# Addendum

**Project:** Harris County Psychiatric Center Renovation  
Units 1C, 2E, 3B, 3C, 3D, & 3E

**Addendum No.:** 002

**Date:** November 14, 2016

**A2.02C**

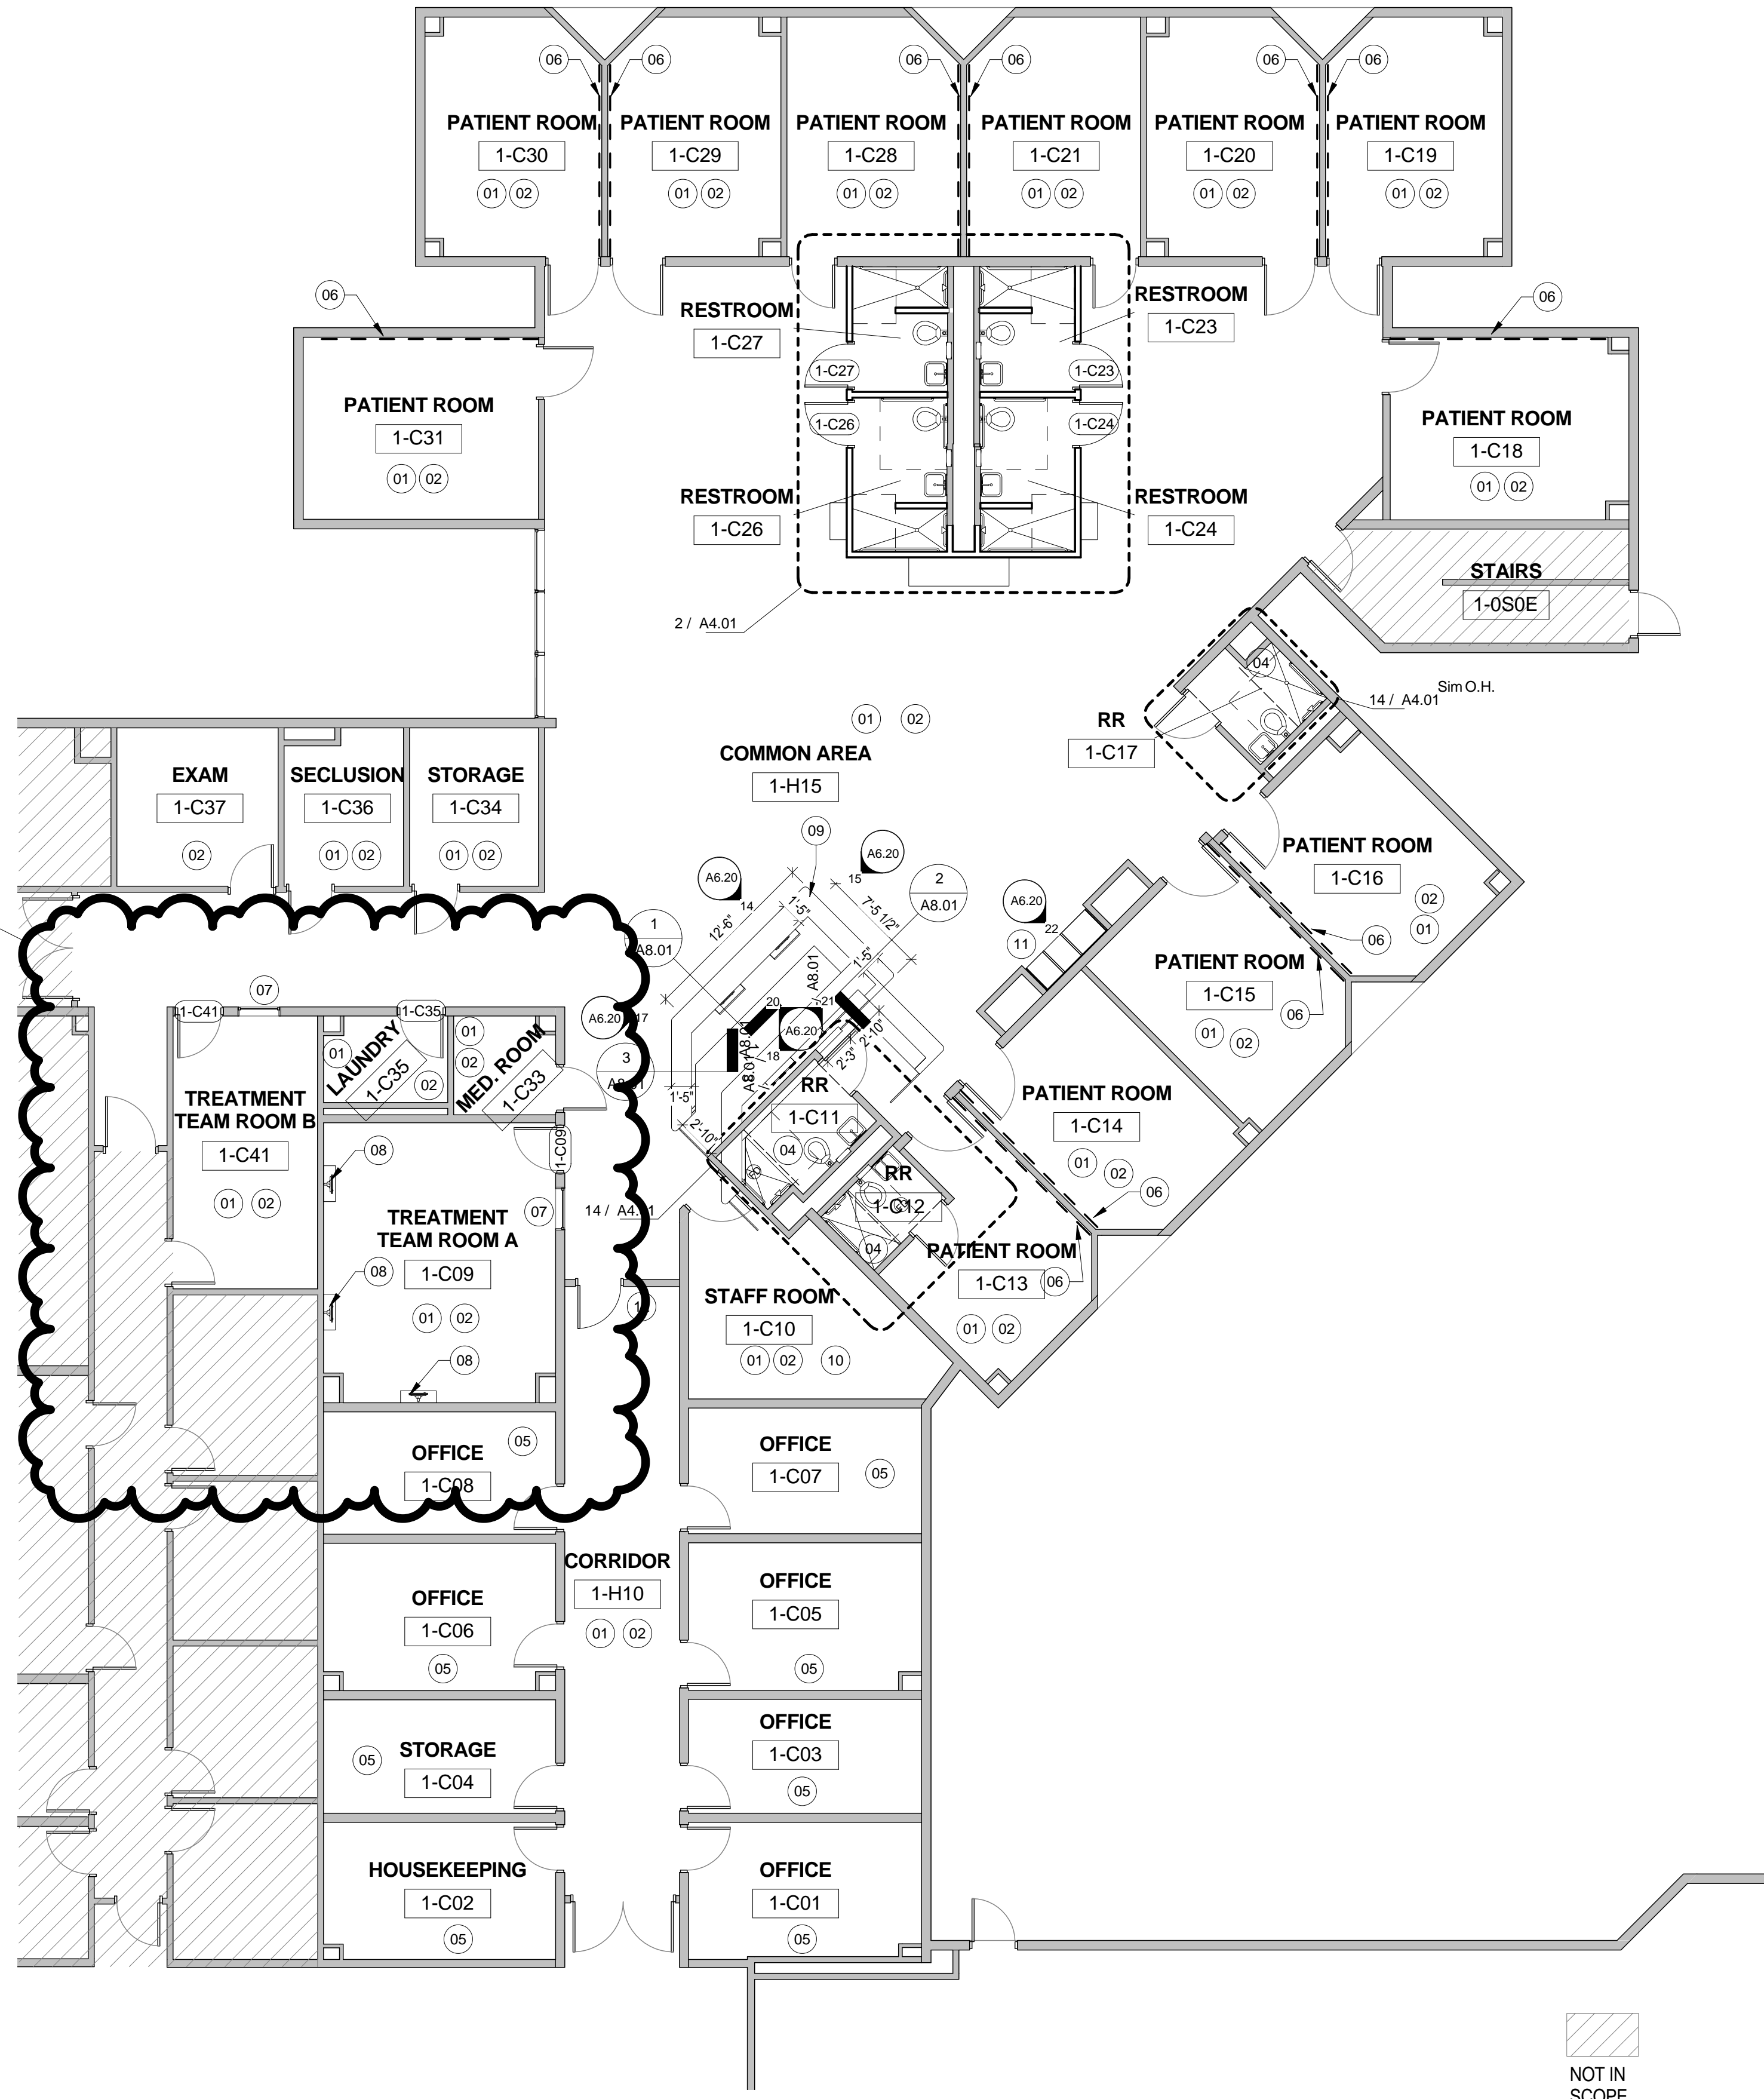
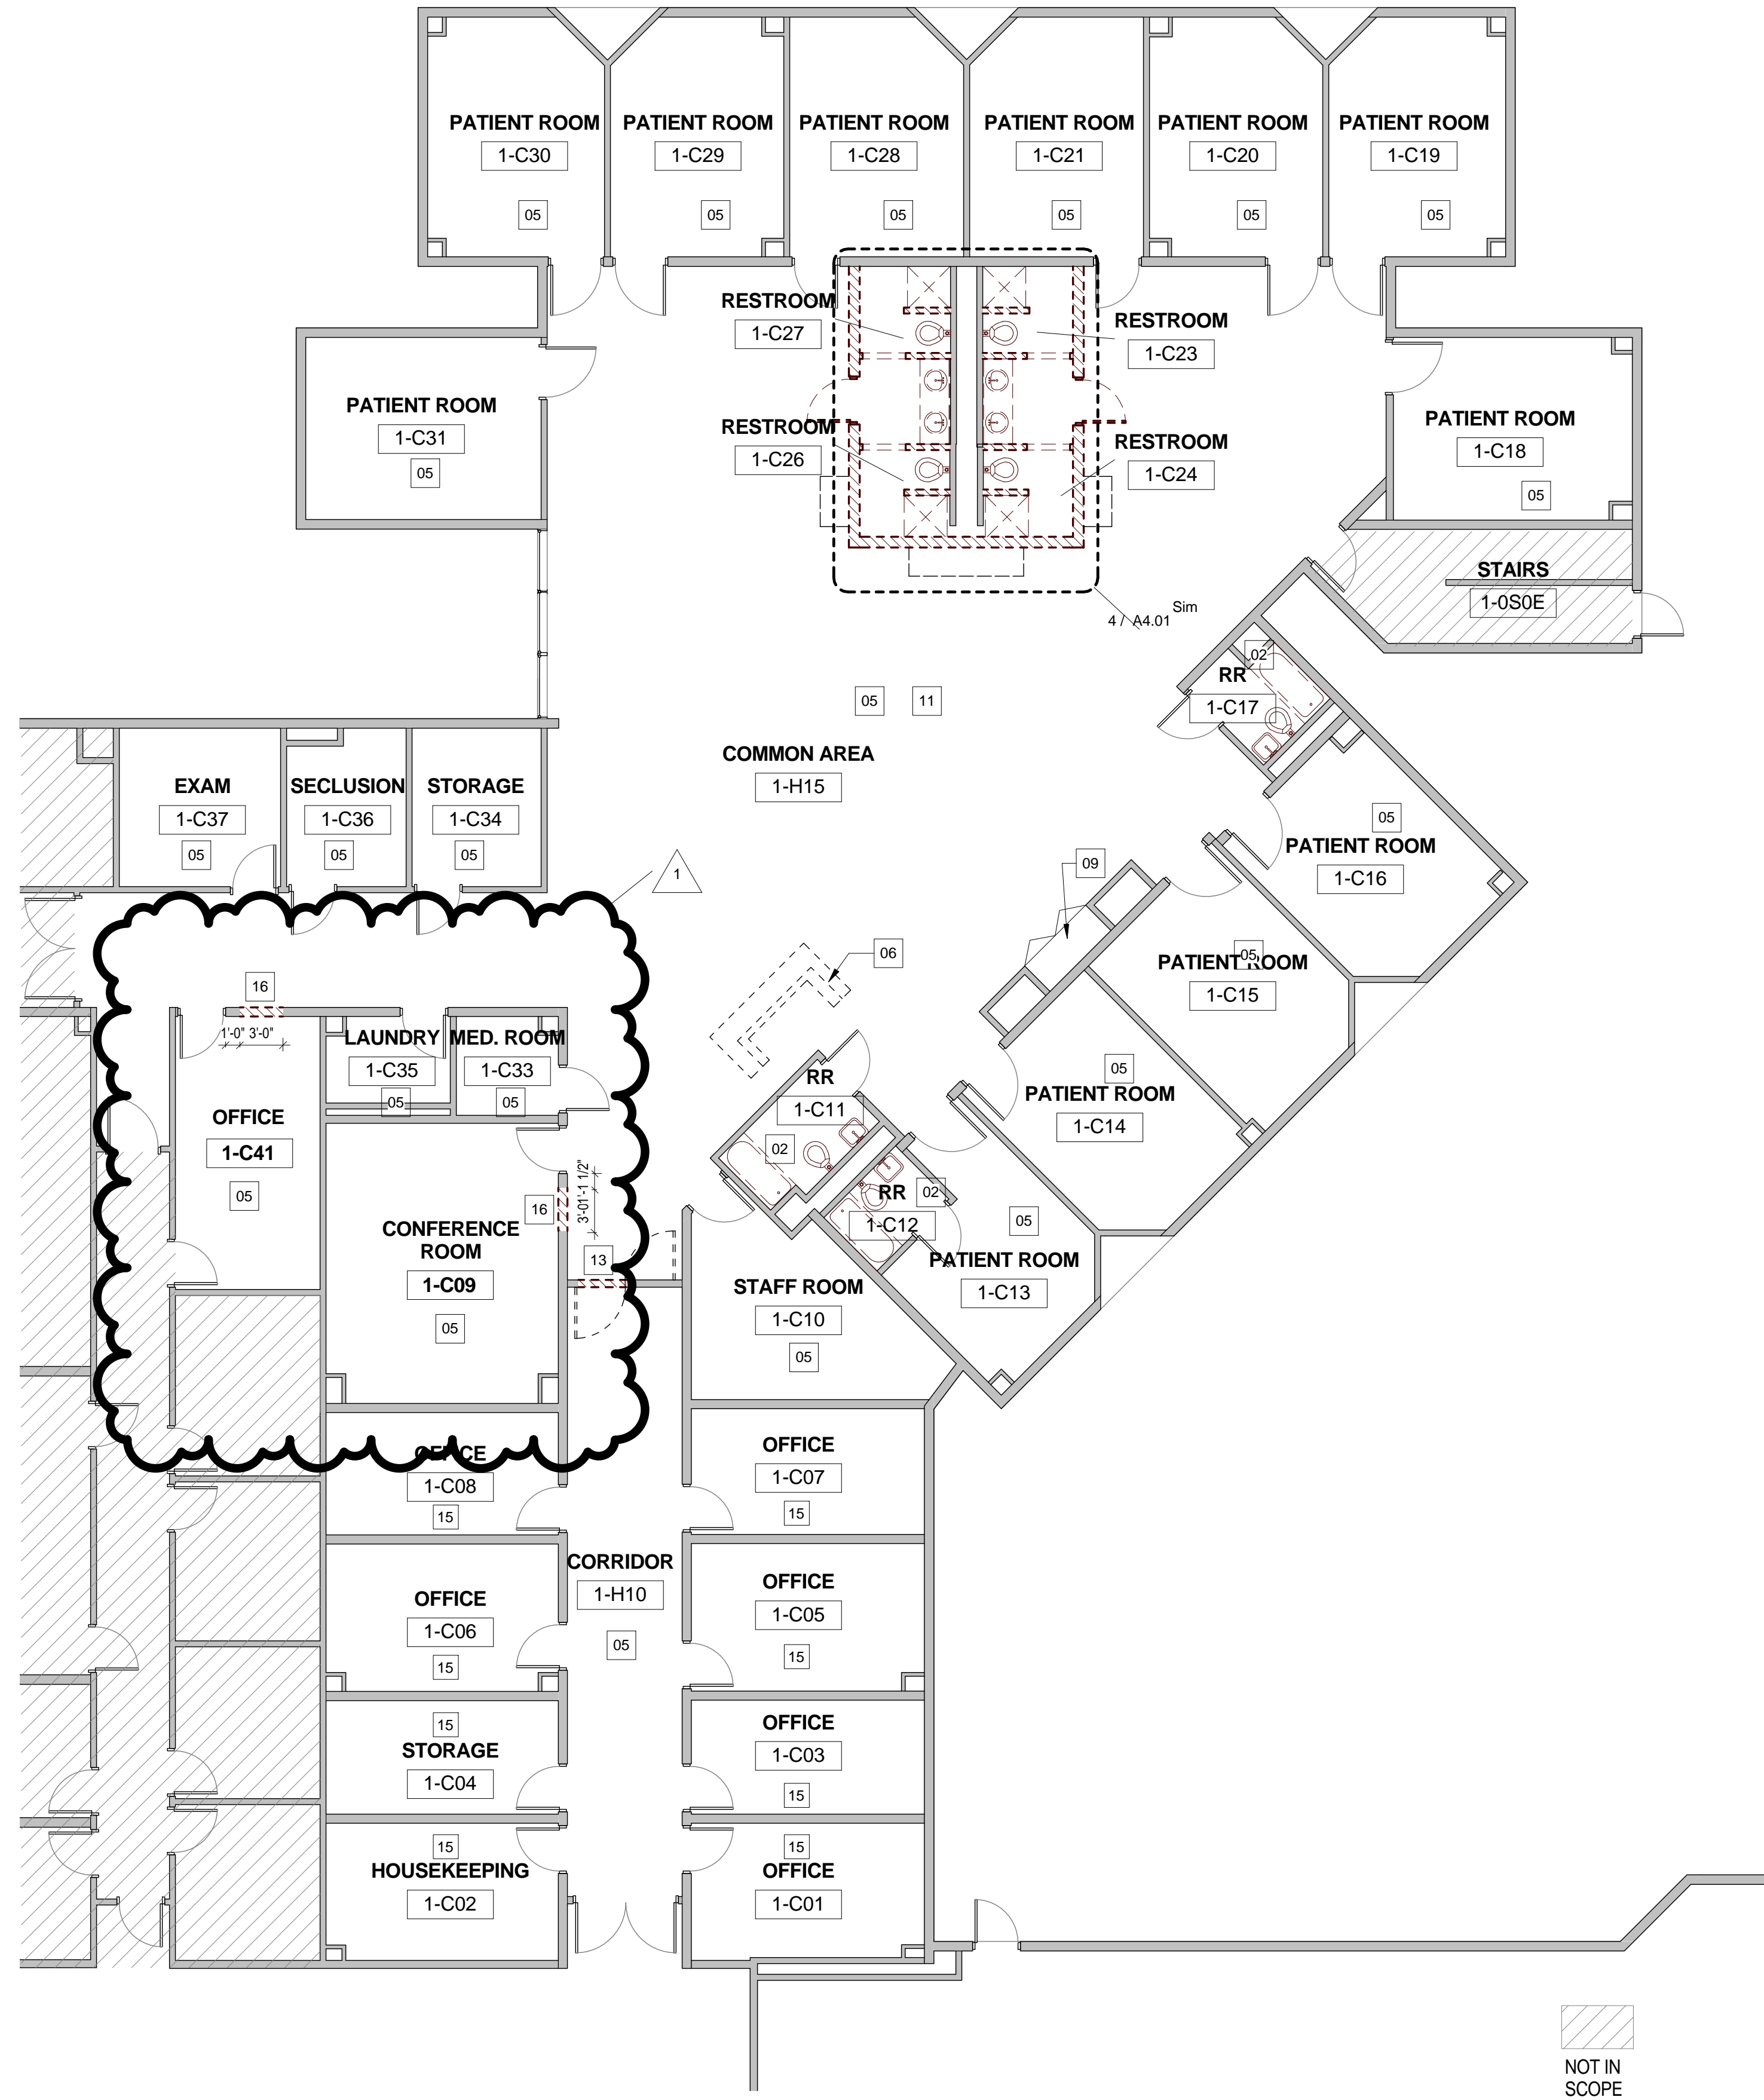
4. Sheet A2.02C, First Floor Unit 1C, revised to reflect changes to keyed notes on demolition and/or renovation plans. (see attached)
5. Sheet A2.05E, Second Floor Unit 2E, revised to reflect changes to keyed notes on demolition and/or renovation plans. (see attached)
